SOLICITATION NO.: ITB 2019-07 Terramar Park Playground Improvement

ADDENDUM NO. 4

DATE: 03/29/2019

TERRAMAR PARK PLAYGROUND PROJECT

SHEET NO. **D-1**
 PROJECT NO. 18245.03

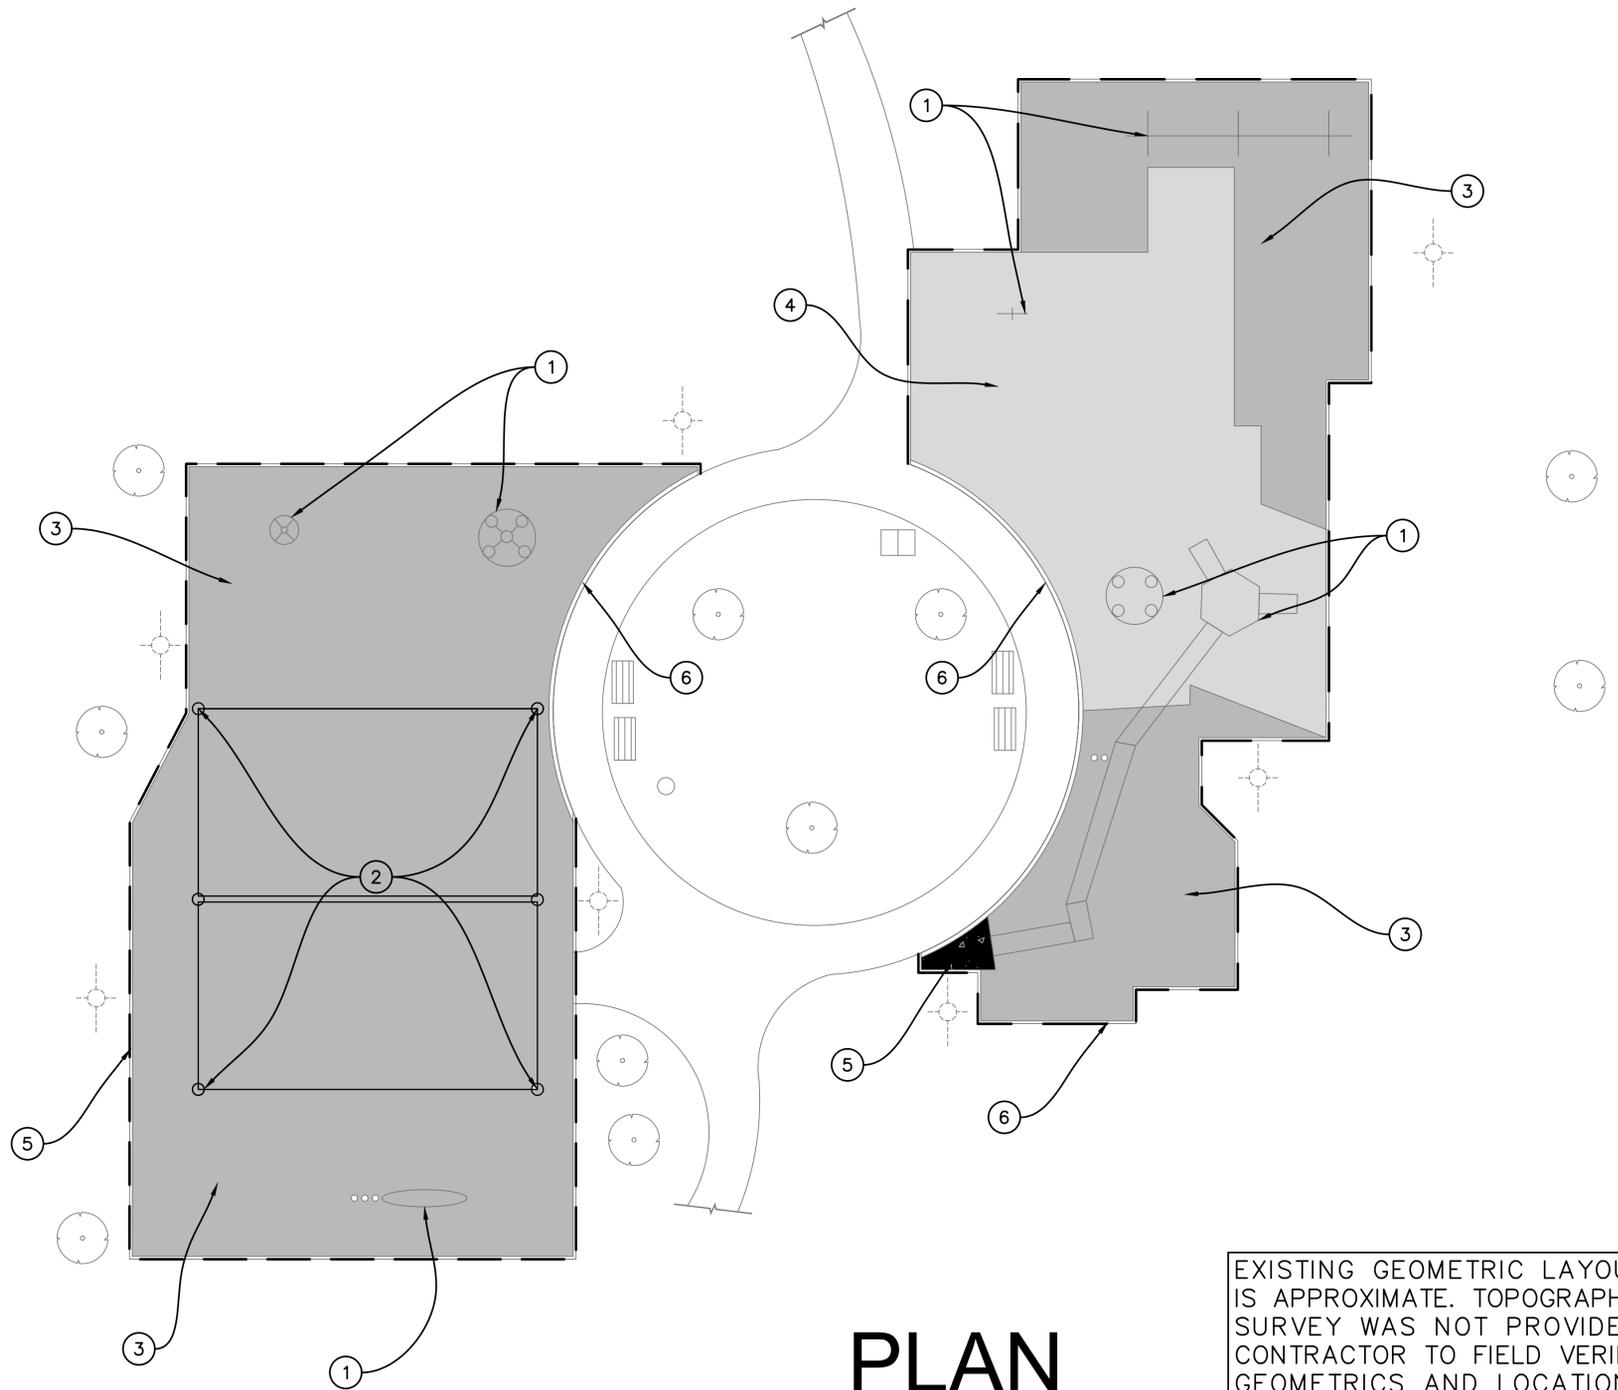
- Sheet D-1, Demolition Plan, Rev. 1
- Sheet C-2, Paving and Grading Plan, Rev. 1
- Sheet LA-3, Site Amenities Plan/Pour-in-Place Layout, Rev. 1

SHEET NO. C-2
PROJECT NO. 18245.03

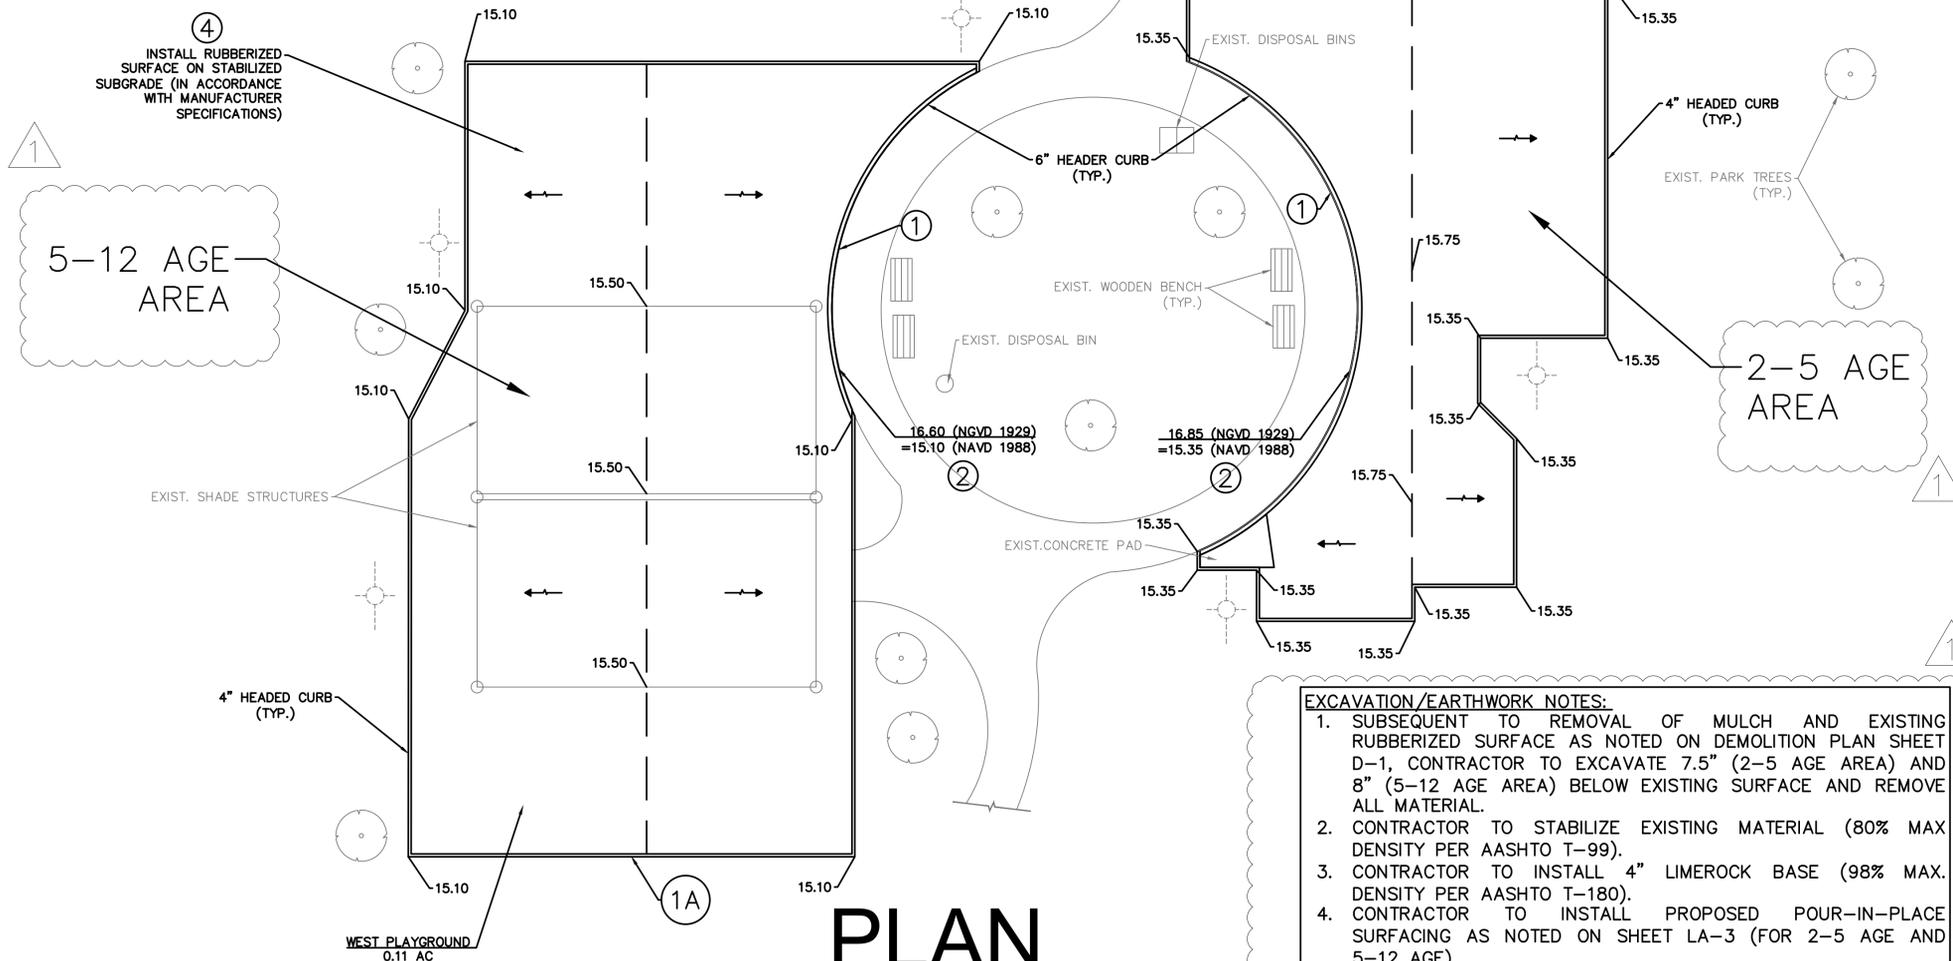
a) *Earthwork:* *Please confirm that they want 850 Cubic Yards excavated. At 12" depth that would be about 22,750 square feet which is more than the playground area.*

Item #3: Confirm they would like the more expensive Lime rock bid for the base. I can't find any reference to Lime rock in the bid, specifically in Earthwork section Div. 31 or on the drawings with the exception of a drawing note stating that density and LBR test results must be provided to the engineer.

Item #4: Confirm they would like 12" Type B Stabilization Subgrade. 12" seems excessively deep as we'll have to excavate over 20" deep to accommodate all the sub-base and surfacing. Also confirm they would like the unit in SY. Again, this is a unit of Area. If so, I will figure it to be 850 SY at 12" depth.

The Contractor is to excavate 7.5" depth (2-5 Age Group Area) and 8" depth (5-12 Age Group Area). Quantity is revised to +/-215 CY in lieu of 850 CY.

Bid Item #3 – F&I 4" Limerock Base (98% Max. Density per AASHTO T-180).

After 7.5" (2-5 Age Group Area) and 8" (5-12 Age Group Area) of excavation, stabilize the existing material to 80% Max. Density per AASHTO T-99.

1. SUBSEQUENT TO REMOVAL OF MULCH AND EXISTING RUBBERIZED SURFACE AS NOTED ON DEMOLITION PLAN SHEET D-1, CONTRACTOR TO EXCAVATE 7.5" (2-5 AGE AREA) AND 8" (5-12 AGE AREA) BELOW EXISTING SURFACE AND REMOVE ALL MATERIAL.
2. CONTRACTOR TO STABILIZE EXISTING MATERIAL (80% MAX DENSITY PER AASHTO T-99).
3. CONTRACTOR TO INSTALL 4" LIMEROCK BASE (98% MAX. DENSITY PER AASHTO T-180).
4. CONTRACTOR TO INSTALL PROPOSED POUR-IN-PLACE SURFACING AS NOTED ON SHEET LA-3 (FOR 2-5 AGE AND 5-12 AGE).
